SS 3112 FTL 2022 P4 Detroit Side Object Detection Harness Rub-Chafe on Bracket

This solution applies to P4 Models specifying Detroit Side Guard Assist.

Figure 1: Side Object Detect (SOD) Harness rubbing points at SRR mounting bracket and ATD cover.

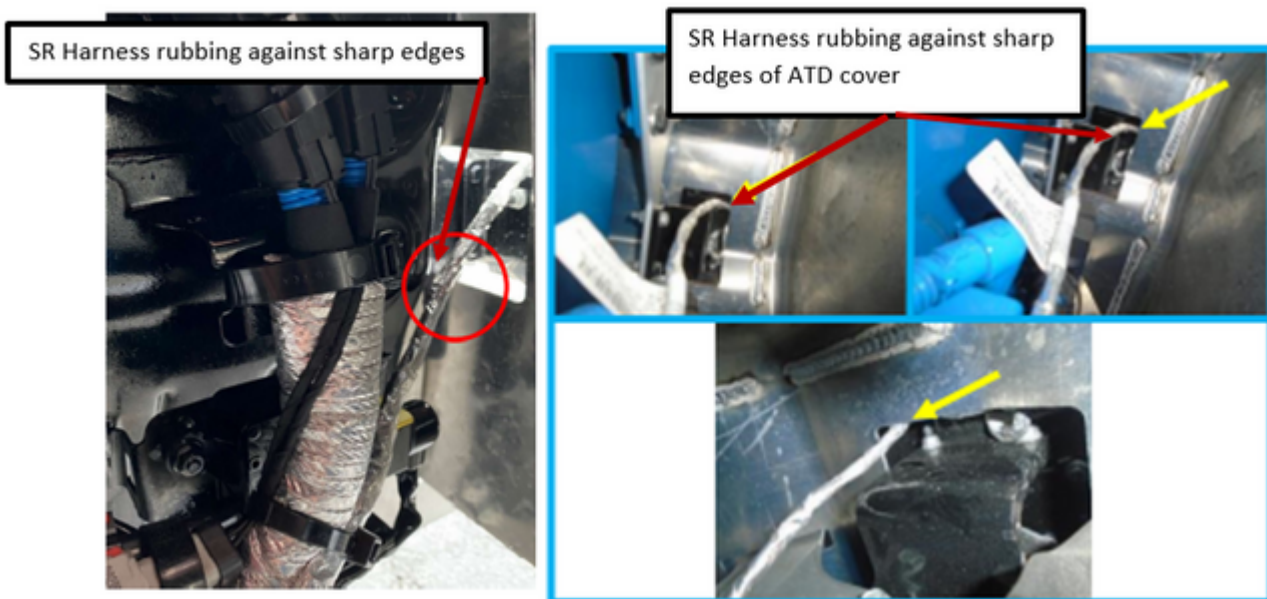
SOD harness may be rubbing the sharp edge of the ATD cover cutout and against the radar support-mounting bracket, causing harness to short out, which trigger several fault codes.

Figure 2: SOD harness installation (Reference: D66-13128-003/4/5)

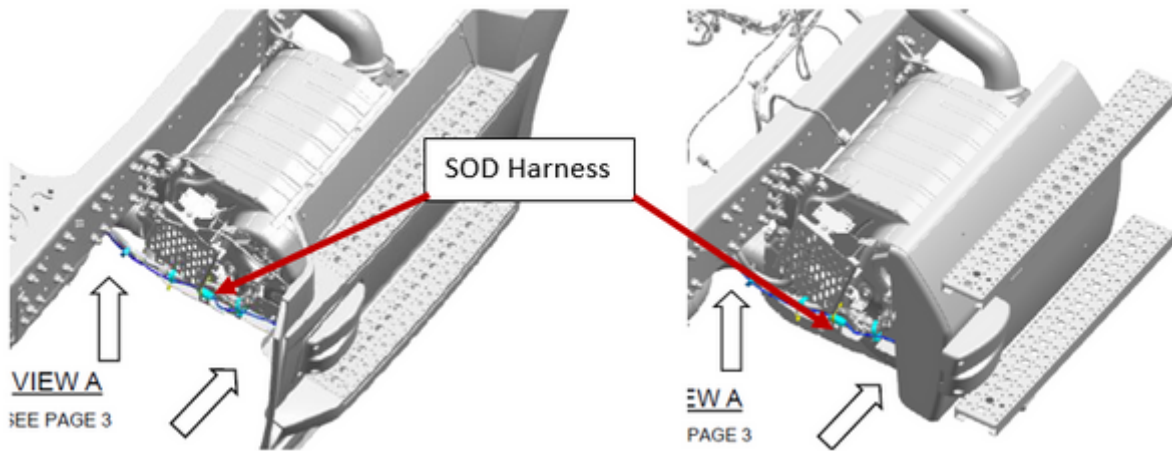
- Access SOD Harness and inspect to identify rubbing and chaffing spots. Remove existing clipping points and inspect and repair harness as needed. Refer to Figure 2 for SOD Harness installation.
